**TOWN OF SUMMERVILLE
COMMERCIAL DESIGN REVIEW BOARD – AGENDA
Summerville Municipal Complex
Annex Building 2nd Floor Training Room
November 17, 2016 4:00 p.m.**

TO: Town of Summerville CDRB
FROM: Planning Staff
DATE: November 9, 2016

Applicant: John Dumas/SE Design
Property Owner: A. David Willis
Requested Action: The applicant is requesting final approval for changes to a previously approved landscape plan.
Requested Approval: Final Approval
Existing Zoning: B-3, General Business
Location: 126 E. 2nd North Street
Existing Land Use: Office Building recently constructed

SITE LANDSCAPE PLAN
 D14.130
L101.b
 10/25/16

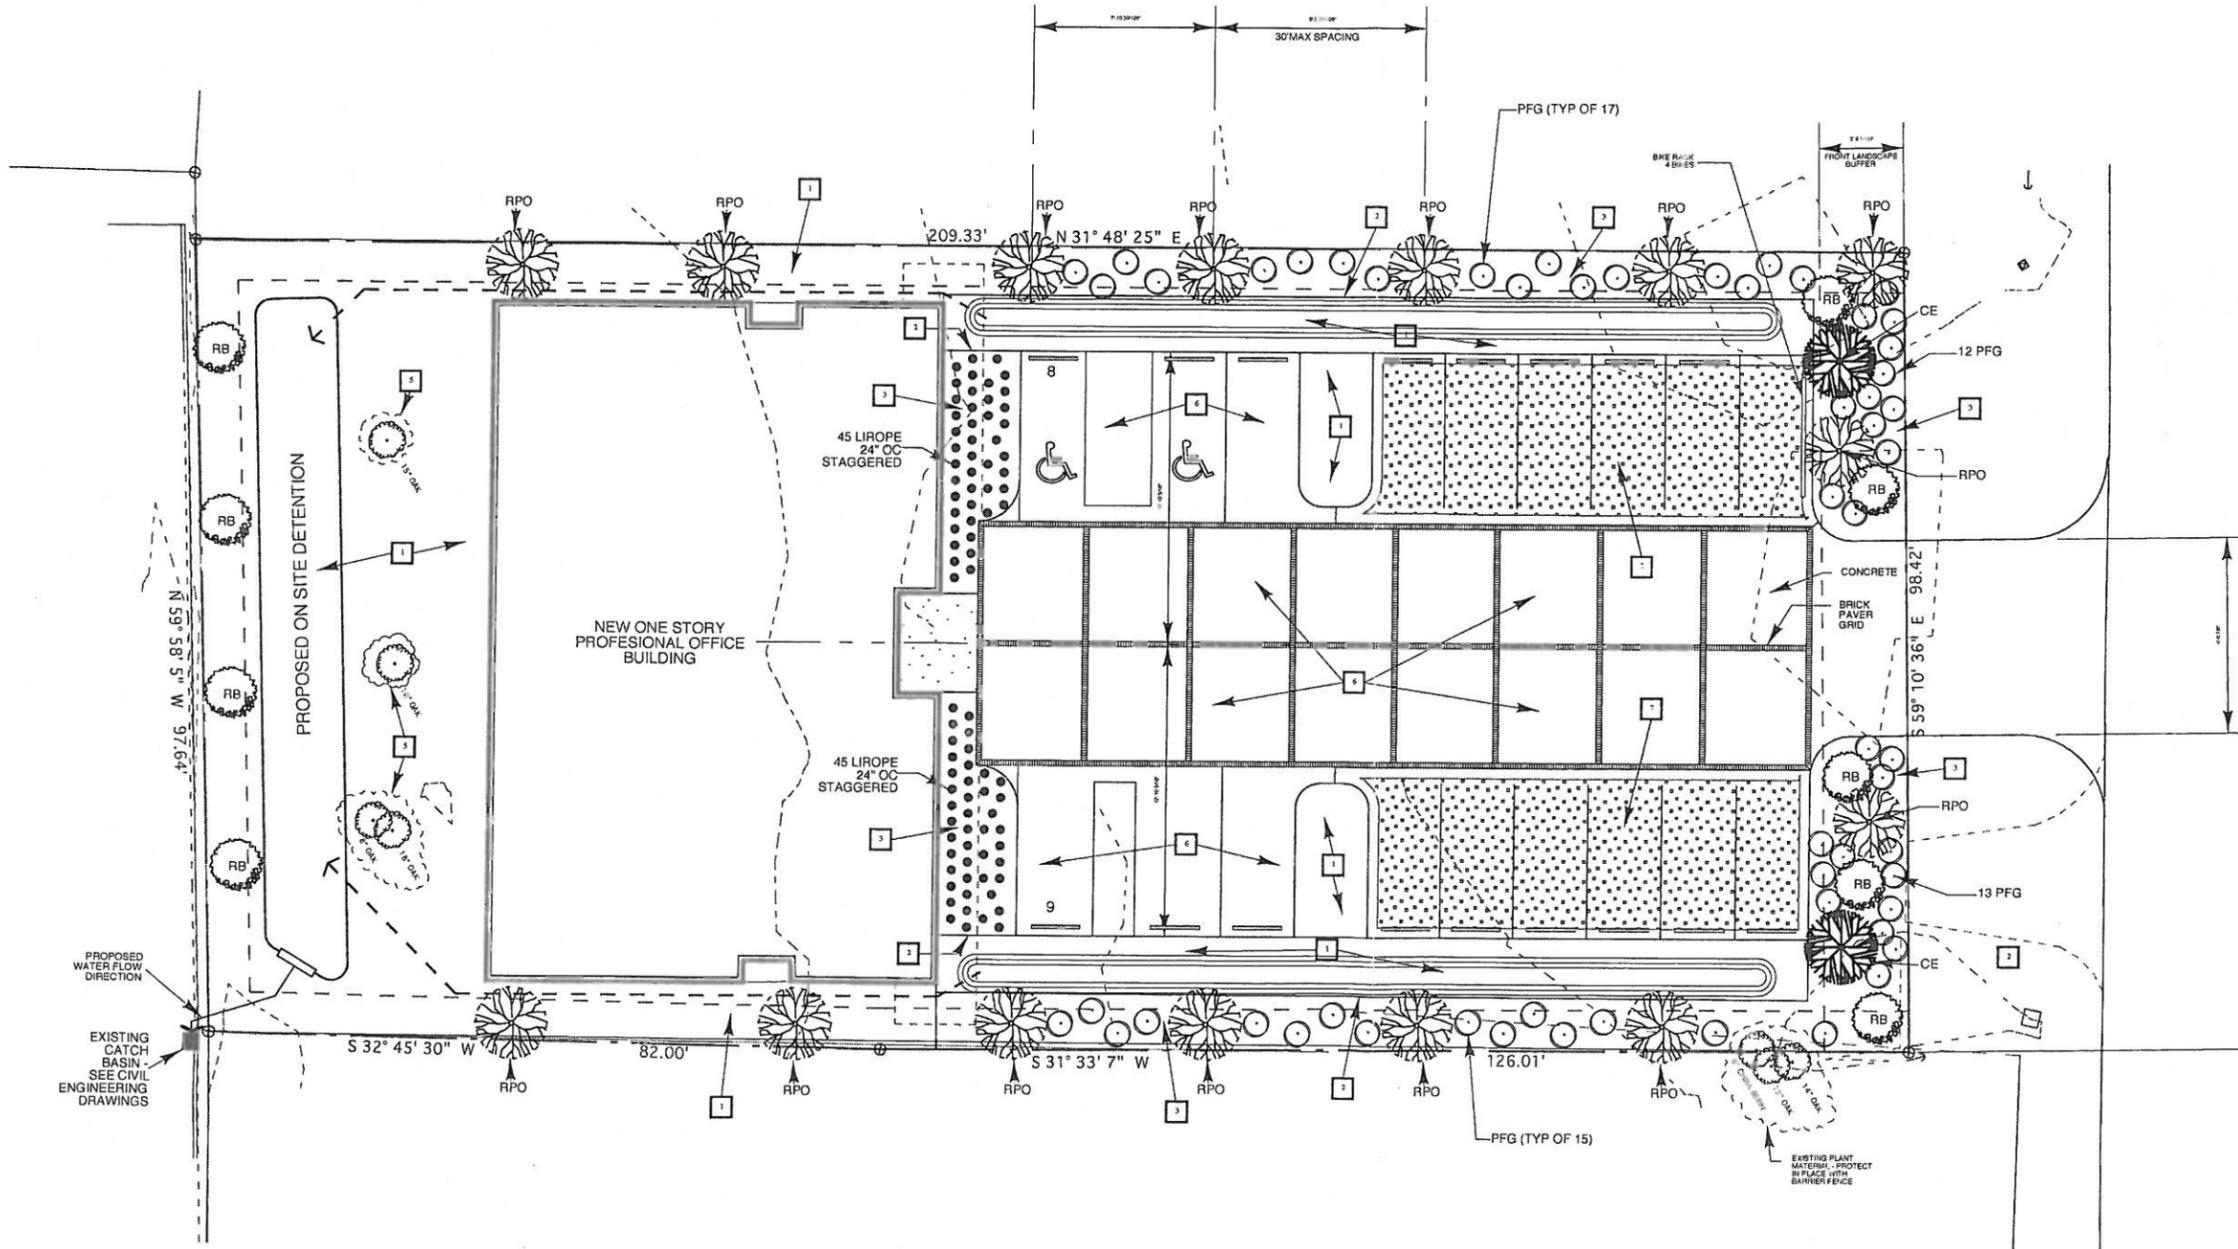
Based upon preliminary staff review, requested changes numbered 6 and 7 do not meet the Zoning Ordinance. The ordinance requires that all parking lot islands be planted with a canopy tree, and that the front border include shrubs two foot in height and shrubs four feet in height. The Board has the authority to approve these changes if they feel it meets the intent of the ordinance. All of the landscape changes proposed must be approved by the Board.

We request approval for the following changes as shown on the attached drawing, L101.b:

1. Delete 6 Crepe Myrtle understory trees at the front planting area adjacent to the front elevation of the building. Reason: The trees will obstruct the glass.

2. Delete 4 Willow Oak canopy trees at the rear property line. Reason: The trees will grow into the existing power lines and will need to be severely cut back within five years. Substitute 4 Redbud understory trees in lieu of the Willow Oaks.

3. Change 15 Willow Oak canopy trees at the side and front planting areas to Regal Prince Oaks. Reason: Recommendation of the landscape subcontractor.
4. Change 2 Willow Oak canopy trees at the front planting area to Regal Prince Oaks. Reason: Recommendation of the landscape subcontractor.

5. Change 2 Live Oak canopy trees at the side and front planting areas to Chinese Elm canopy trees. Reason: Recommendation of the landscape subcontractor.

6. Delete 2 Live Oak and 4 Crepe Myrtle trees at the two parking separator islands and install sod. Reason: Owner does not want to have trees at these two planting locations since they will eventually cause damage to the adjacent concrete paving and because the trees will obstruct the view of the building. Since there are only 8 parking spaces on one side of the parking area and 9 parking spaces on the other side, the owner requests a waiver of the island tree planting requirement.

7. Change all shrubs in the side and front planting areas to Purple Fountain Grass. Quantities would remain the same as the count for shrubs previously indicated. Reason: Recommendation of the landscape subcontractor and the due to the owner's preference.
